MINUTE 4 OF THE EXPERT PANEL

Request for Information
Mt Welcome, Pukerua Bay, Porirua
FTAA-2603-1181

(6 July 2026)

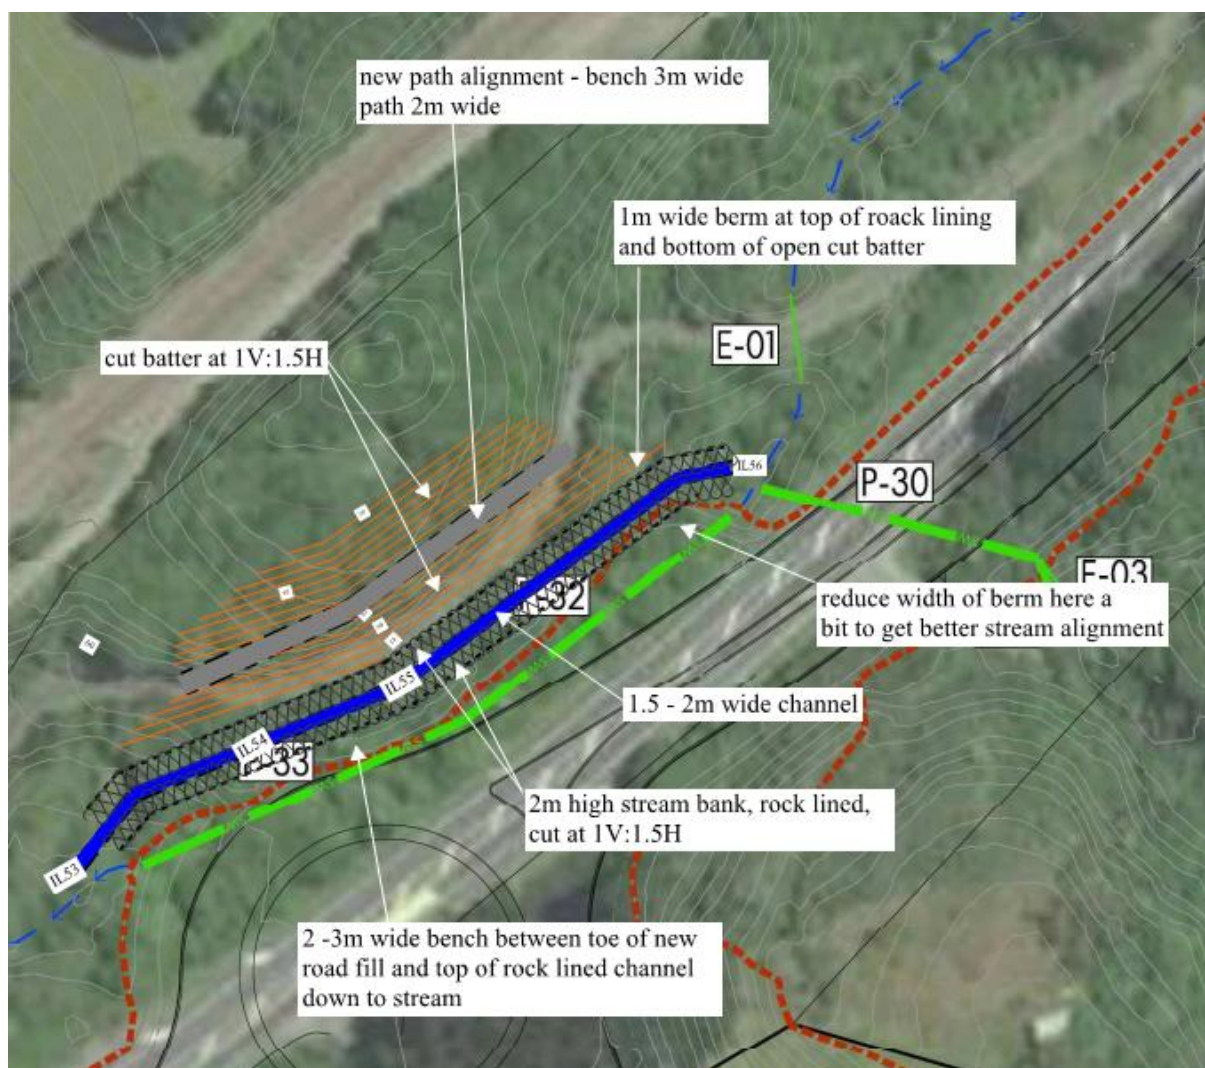
[4] As regards the latter, inspection of the landform in the immediate area of the proposed roundabout suggests to the Panel that it might be feasible to construct a realigned section of stream to the west of the proposed roundabout to eliminate the need for a culvert. This alternative option would also require realigning a section of existing pathway to the west. A schematic of this option is

shown in the image below:

[5] The scale of construction work associated with this option appears to be modest in comparison with the proposed culvert as the length of the works are similar, the earthworks involved are not likely to exceed 10,000m³ and the risk of blockage would be eliminated. This combination of factors suggests to the Panel that realignment of the stream might be found to have merit on proper examination and analysis, including after consultation with Te Rūnanga a Toa Rangatira, notwithstanding the additional SNA clearance that would be required.

[6] The Panel requests that the applicant advise if it has previously considered some form of stream realignment and, if so, what its reasons were for preferring the proposed culverting option. If the applicant has not previously considered

some form of stream realignment, the applicant is requested to provide an analysis of the pros and cons of the concept shown above, or variations thereof that the applicant's advisors might identify, relative to the culverting proposed.
